Sandy Spring Townhomes: Limited Site Plan Amendment No. 82016001B in Response to a Violation

Staff Report Date: 1/17/20

Limited Site Plan Amendment No. 82016001B:
Request to modify the layout of the turnaround plaza with associated seating and pergolas, modify condition 7b to require a 5'-0" sidewalk, modify condition 8 to update lot numbers that require special treatment and allow beaded vinyl siding at the end walls of highly visible facades, modify steel fencing details, modify the cap on brick piers; located on the south side of Olney Sandy Spring Road (MD Route 108) in between Norwood Road and Meeting House Road; 2.31 acres zoned CRN-0.75 C-0.25 R-0.75 H-45; *2015 Sandy Spring Rural Village Plan*.

Figure 3: Emergency Vehicle Turnaround Plaza with Seating and Pergolas
(left previously approved, right proposed)

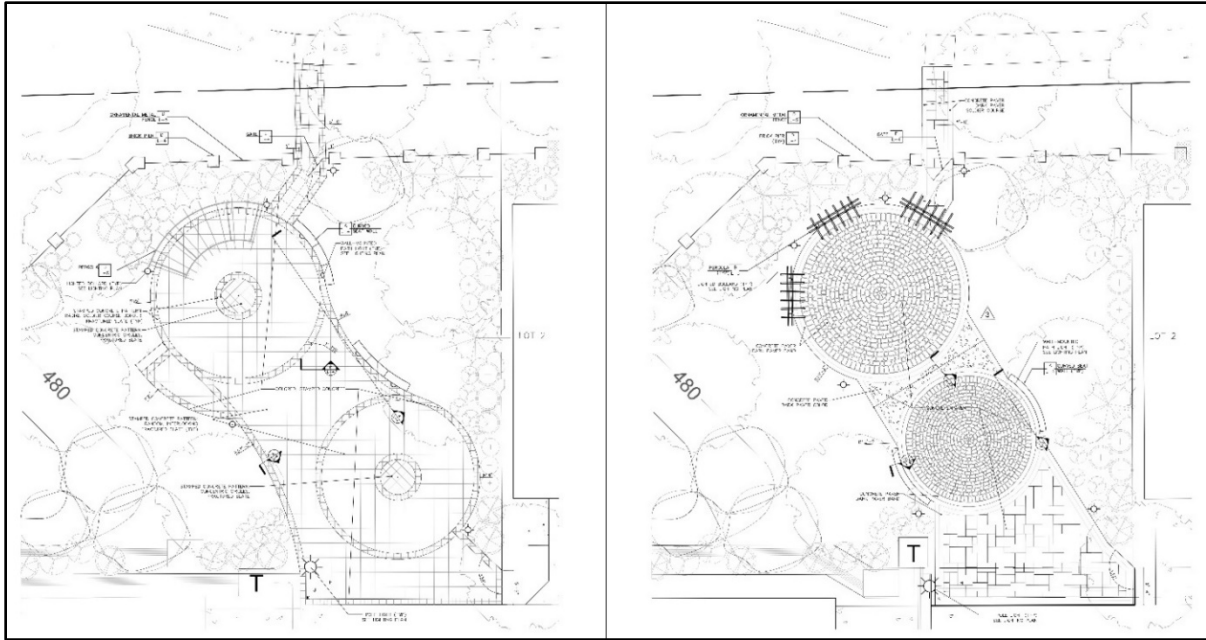
- the layout and configuration of the emergency vehicle turnaround plaza with seating and pergolas (Figures 3 and 5);
- modify condition 7b to require a 5'-0" wide sidewalk instead of the previously approved 4'-0" width;
- modify condition 8 to update lot numbers that require special treatment and allow beaded vinyl siding at the end walls for highly visible facades of the townhomes on lots 3, 8, and 9;
- modify the ornamental metal fencing details to reflect the configuration that was installed (Figure 4);
- modify the cap on the brick piers from a precast cap to a sloped 30" square bluestone cap in order to reflect what was installed (Figure 4).

2. Layout and configuration of the emergency vehicle turnaround differs from the CSP in terms of geometry, materials, and paving patterns and details.	Amend CSP

5. The single curved pergola was installed as three separate smaller pergolas.	Amend CSP
6. Seat walls were replaced with non-continuous arched walls which differ in locations, size, height, and length.	Amend CSP

Figure 4: Metal Fencing and Pier Cap (left previously approved, right proposed)

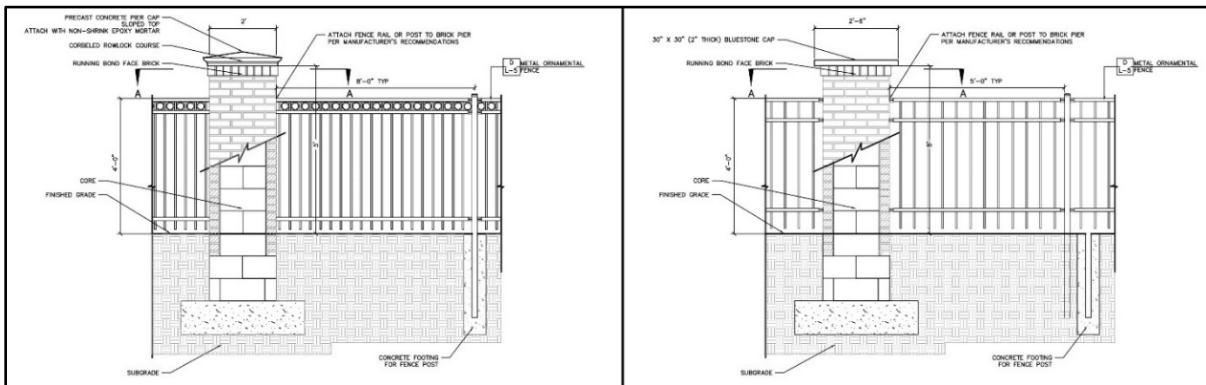
3. A building permit is required for all fencing installed on-site.	N/A
4. The caps on the brick piers are bluestone instead of precast concrete.	Amend CSP

PAVEMENT SECTION - FIRE DEPT. TURNAROUND
TYPICAL FOR ENTIRE PLAZA
 NTS

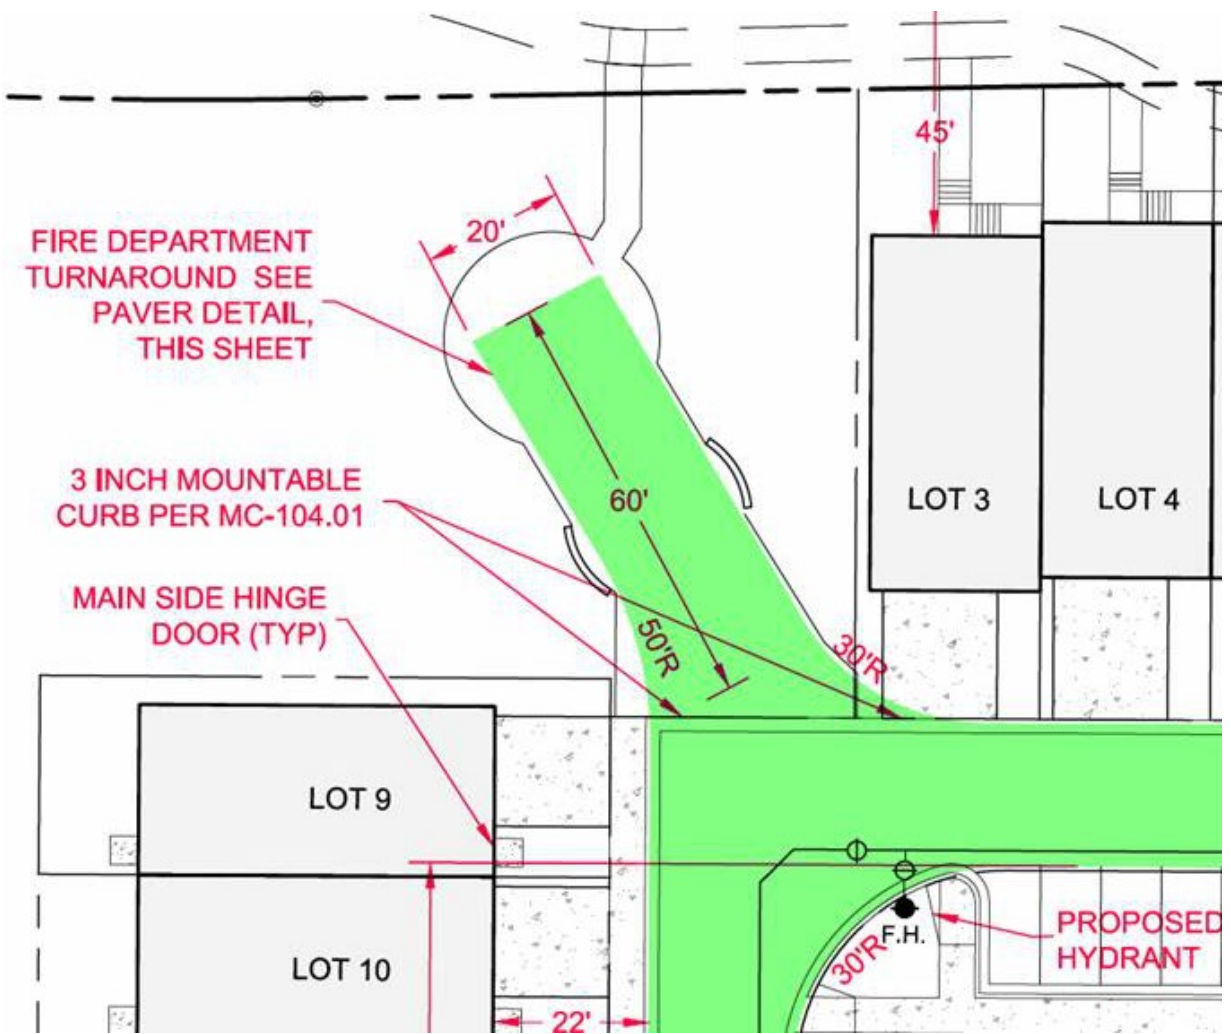
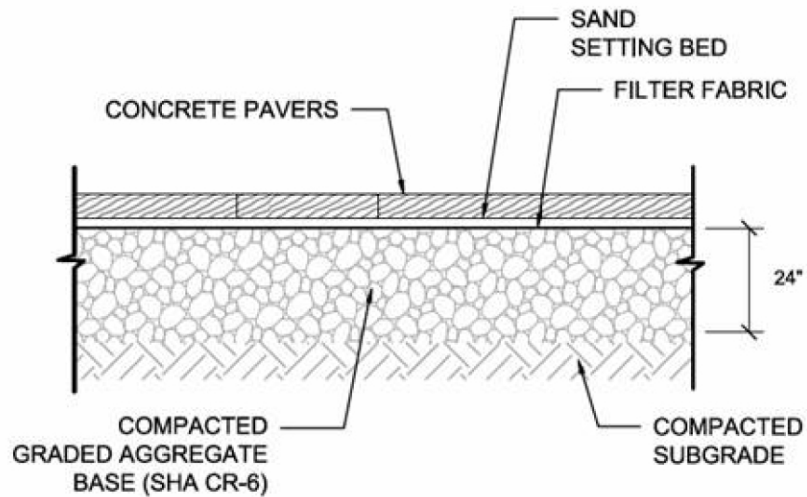
Below are the relevant details from the Feb 18, 2016 approved fire department access plan. As per Montgomery County Executive Regulation 8-16, everything in green (including the corner where Lot 2 meets the pedestrian plaza) is designated as fire department vehicular access and therefore must meet minimum load bearing requirements for either Montgomery County tertiary road standard or MCFRS apparatus, no less than 85 kips, whichever the applicant chooses to meet.

You will notice a significant difference in the subgrade section. The latest submittal was not certified by a geotechnical engineer or sealed by a professional engineer as able to meet required load bearing minimums.

- 14. Prior to Certified Site Plan, the Applicant must submit a Fire Department Access Plan that is certified by a geotechnical engineer or sealed by a professional engineer as able to meet minimum load bearing requirements for either Montgomery County tertiary road standards or MCFRS apparatus, or as approved by DPS Fire Department Access and Water Supply.

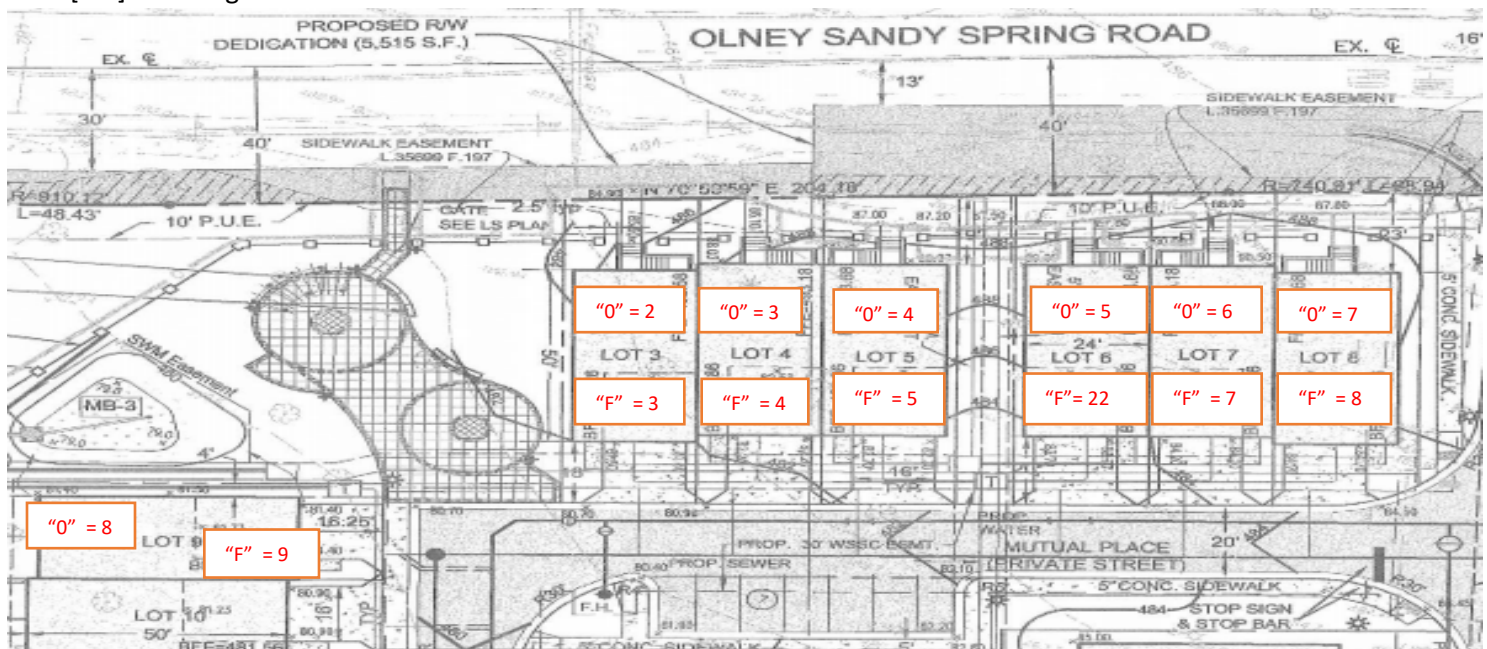
Lot number clarification: The original lot designations for those lots along Route 108/Olney Sandy Spring Road (moving west to east – left to right across the CSP – were Lots 2, 3 & 4 in the first stick and Lots 5, 6 & 7 in the second stick with Lot 2 being the closest lot to the common open space/turn-around plaza (located in the northwest corner of the property/project). The end lot of the stick of townhouses just south of the plaza was identified as lot 8. This is important since the "O" (original) Resolution detailed specific requirements for Lots 2, 7 and 8 (all end units on the 3 sticks of townhouses closest to Route 108/Olney Sandy Spring Road and what might be considered as "Highly Visible"). In the various reiterations of the lots, in the A Amendment, Lots 2, 3 & 4 became Lots 3, 4 & 5 and Lots 5, 6 & 7 became Lots 2, 7 and 8. And Lot 8 became Lot 9. The final plat reflects the change of Lot 5 to 6 and then finally to Lot 22. The important result is that the original lots reflected in the original CSP (Lots 2, 7 & 8), ultimately became Lots 3, 8 & 9 at the conclusion of the project. These changes are reflected in the plans provided below:
